DEVELOPMENT ASSESSMENT REPORT				
Application No.	D/2019/503			
Address	F 1/1-15 Barr Street BALMAIN NSW 2041			
Proposal	Change of use from commercial to a residential unit within an existing two and three storey commercial and residential building, and associated alterations and additions.			
Date of Lodgement	05 December 2019			
Applicant	John Greenwood & Associates Pty Ltd			
Owner	RGC Custodians Pty Ltd			
Number of Submissions	Nil			
Value of works	\$278,200.00			
Reason for determination at Planning Panel	Clause 4.6 variation exceeds 10%			
Main Issues	FSR; Adaptive Reuse; Heritage; Amenity; Stormwater; BCA			
Recommendation	Refusal			
Attachment A	Draft conditions if not refused			
Attachment B	Plans of proposed development			
Attachment C	Clause 4.6 Exception to Development Standards

This report is an assessment of the application submitted to Council for a change of use from commercial to a residential unit within an existing two and three storey commercial and residential building, and associated alterations and additions at Unit F1/1-15 Barr Street Balmain.

DRAINAGE OF PROPOSED COURTYARD

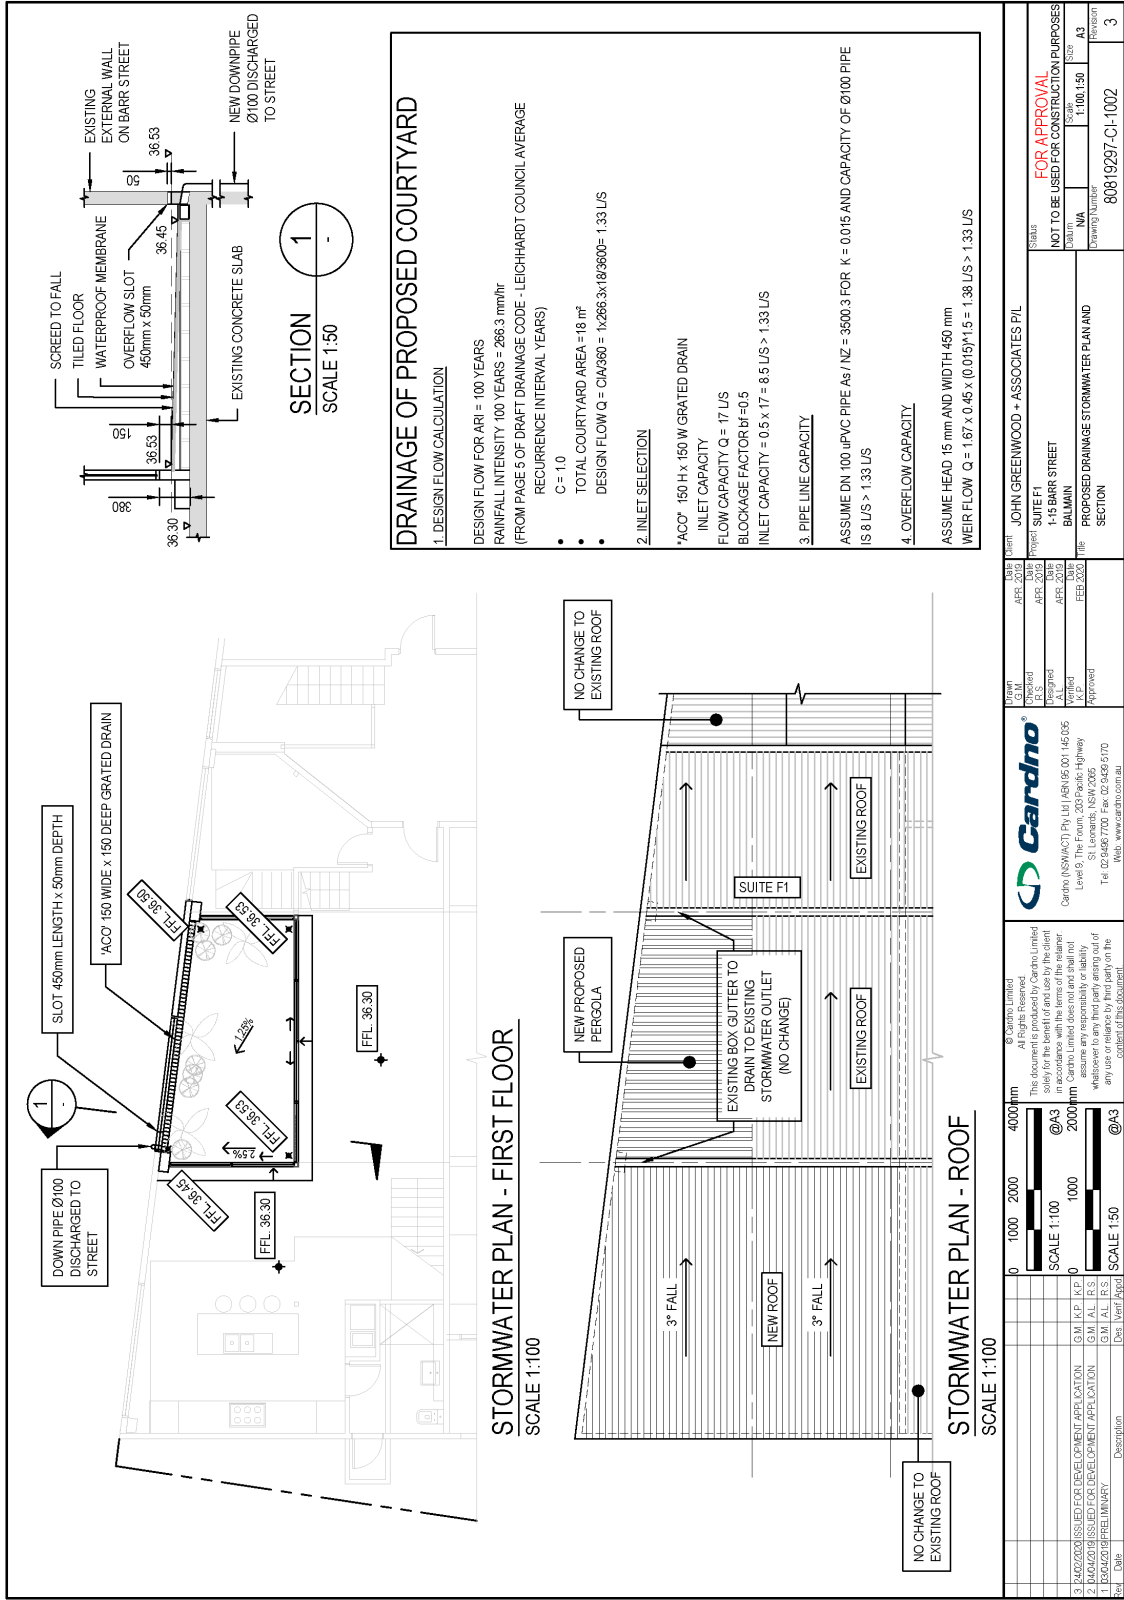
- a) *The area of the proposed New Operable Louvered Roof on the stormwater plans must match the architectural plans.*
- b) *The proposal appears to propose an overland flow path from the courtyard surface through the front façade to Council's footpath on Barr Street via a 1150mm long x 80 high slot. This is not supported. The proposal must demonstrate that all surface flows from the courtyard are collected in a system of pits and pipes and connected directly to the existing site drainage system.*
- c) *The plans do not clearly identify that there is a 150mm step up must be provided from the finished floor level of the courtyard to the adjacent internal areas to prevent ingress of water to internal areas that are adjacent the courtyard.*

- g. The overflow SLOT 450mm LENGTH x 50mm DEPTH must be deleted from the plans. Drainage must be via the pit and pipe system.
- h. As there is no overland flow/flood path available from the rear and central courtyards to the Barr Street frontage, the design of the sag pit and piped drainage system is to meet the following criteria:
